TITLE: SKETCH PLAN

Thank you for the opportunity to review the **First (1st) Plan Review Submittal (a SWM Concept Plan)** prepared and submitted by **Design Engineering, Inc. on March 6, 2025** for the proposed **Sonina Properties Apartment Improvement (SHA Project No. 25APMO021XX)** on **MD 193** (University Blvd - Mile Point **6.52**) in **Montgomery County**, Maryland.

DATE: 11-Apr-25
TO: Pritam Arora - parora@deius.com
Design Engineering Inc
FROM: Marie LaBaw
RE: Sonina Properties Apartments
320250010

RE: Sketch Plan No. 320250010
Sonina Properties Apartments

2nd-3rd-4th Floor Plan

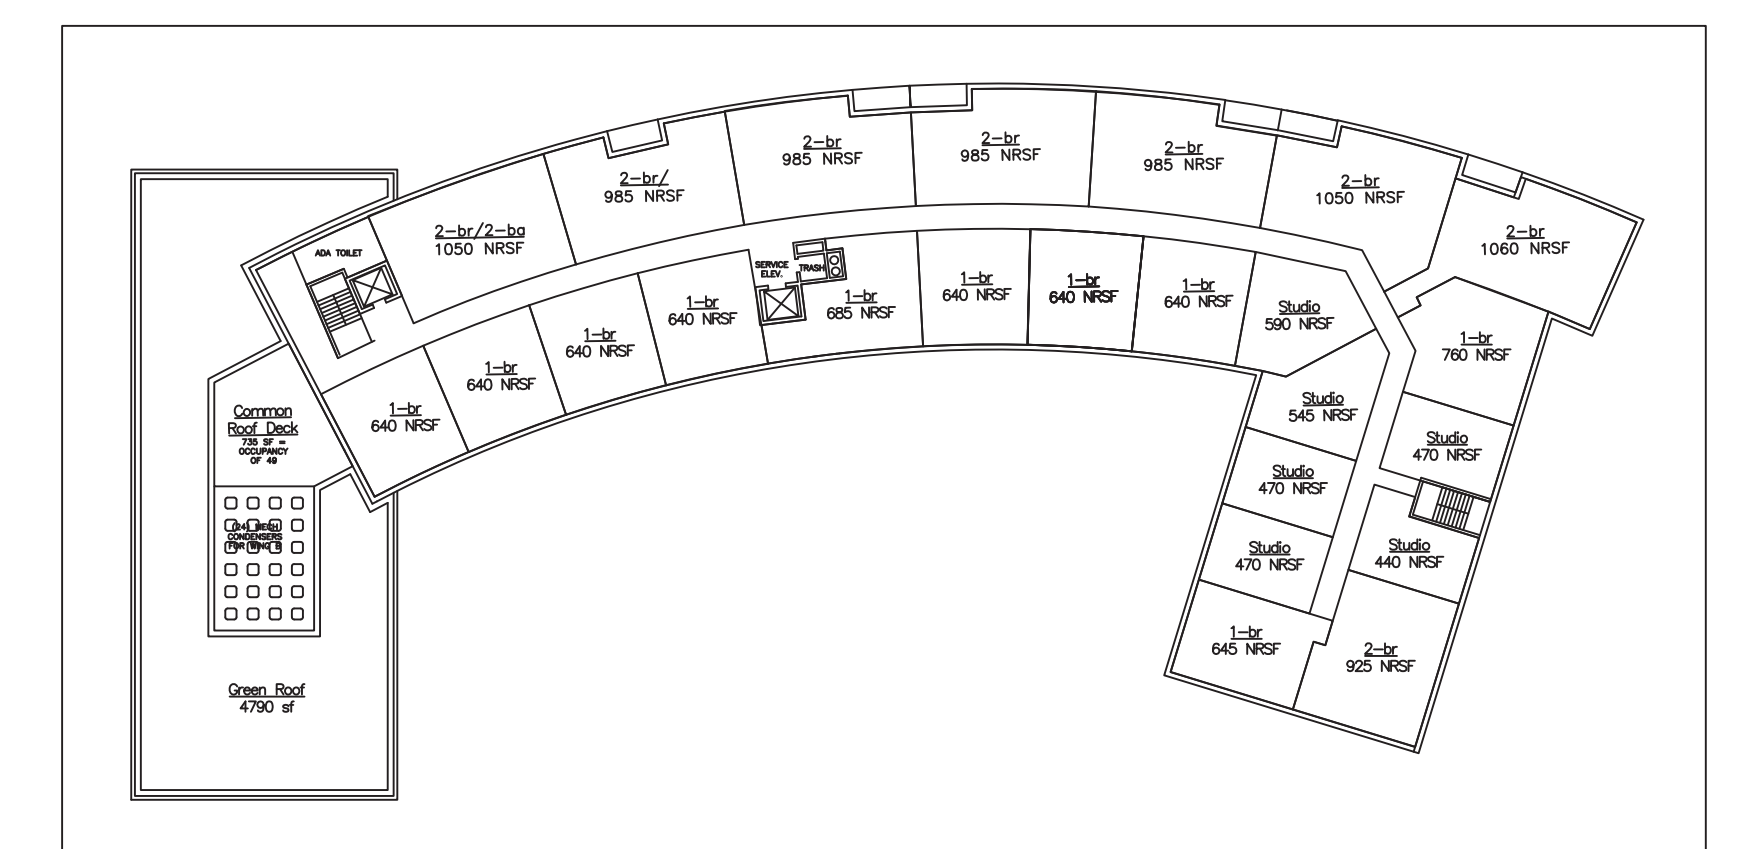
***** MCDOT to coordinate bike lane protections at hydrant with MCDPS Fire Department
Access & Water Supply *****
